INDESIT company

Model type:
AVXXL109EX

Commercial code:
F033724

n1040398: Programme keys aligned.

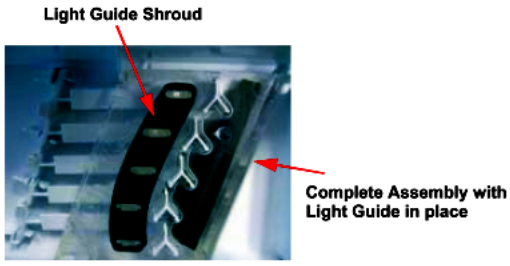
From serial no. 51118.0001, a specially shaped foam pad has been inserted between the keypad and light guide on washing machines AVXXF and AVXXL and washer-dryers AMFFX and AMXXL. The part code of this new component is C00142393 (fig. 001).

This new part separates the keys and pushes them outwards together to ensure they are perfectly aligned.

The pictures in figures 002 and 003 illustrate how the foam pad should be fitted on the keypad and subsequent assembly of the light guide with relative light guide bracket, code C00142648.

The new parts C00142393 and C00142648 can also be used on premodification appliances.

n4008c02: Rear drum replacement

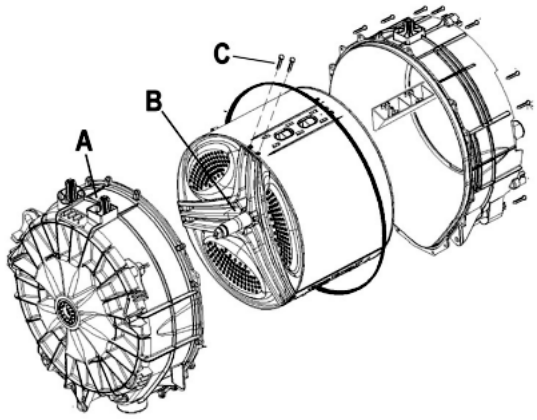
All drum service replacements use 35mm bearings

When you use in assistance the rear drum you will also need to change the drum bearing spider from the 30mm version to the 35mm version

A = C00119357 Drum Rear
B = C00117329 Drum Bearing Spider
C = C00201310 Drum Bearing Spider screws (Qty 6)

Production use 3 screws but for Service we suggest that 6 screws are used.

n0508c01: Door Gasket Clamp Band

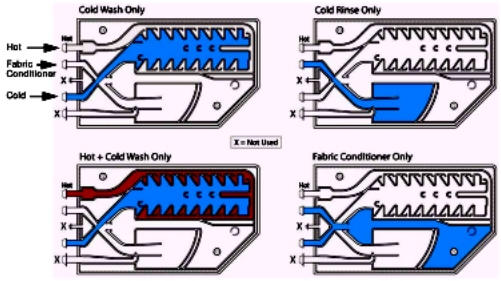
A New Polypropylene Gasket clamp band has been introduced in production from Serial number 80325.0000
The purpose is to provide added support to the inner rim of the door gasket.
